TECHNICAL SERVICE BULLETIN

71 B 12

Fresh Air Heater Controls Outer
Cable Retention.

Austin America

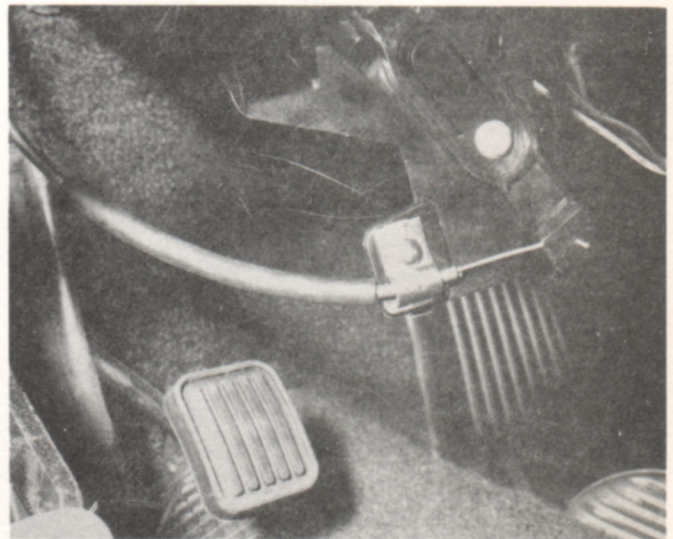
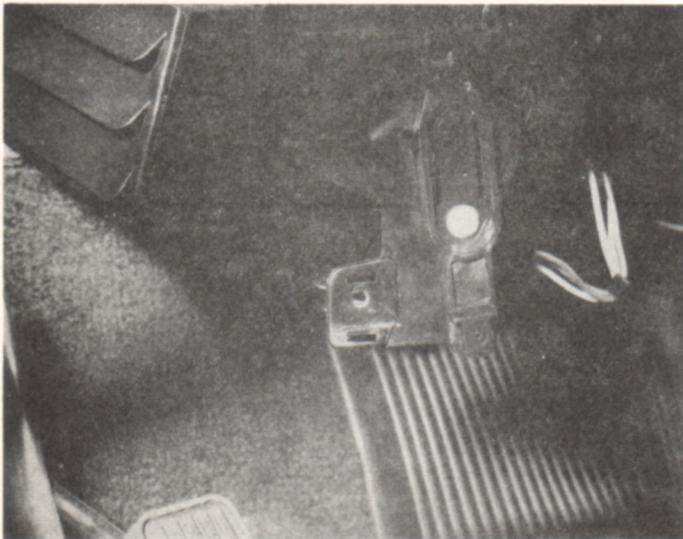
If the outer cable retention clips fail to hold, the following method of repair may be employed:

Remove heater control panel, invert and drill a 3/16" hole as indicated below 5/8" from bottom of flange, center point from side to side.

Install clip, part number 27H1193, and secure to panel with a 8/32 x 1/2" screw and nut.

It may be necessary to slightly increase the bend in the clip if the plastic cracks at the original clip slot.
